CHERRYWOOD PARC

A TRACT OF LAND BEING PART OF SECTION 4,
TOWNSHIP 46 N., RANGE 3 E.,
CITY OF O'FALLON, ST. CHARLES CO., MO.

Sheet 1 of 23
S C ST. CHARLES ENGINEERING & SURVEYING
E/S 801 South Fifth Street, Suite 202
St. Charles, Missouri 63301
Off. 947-0607, Fax 947-2448
Order No. 94-306
Date 7/12/94

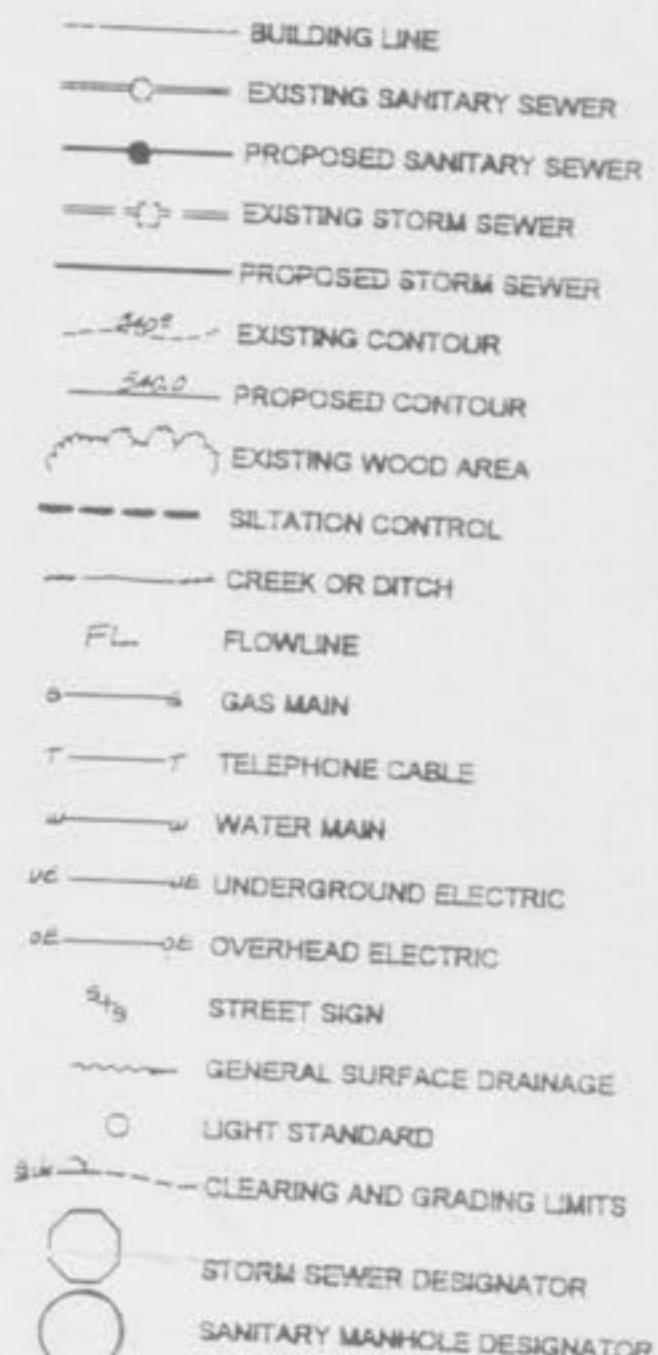
APPROVED

CONTINGENT ON:
Adding an inlet to intercept water
above At 6' so as to limit
overland flow to less than 4.0 cfs.

Review by GBA
J. Payne
11-21-94
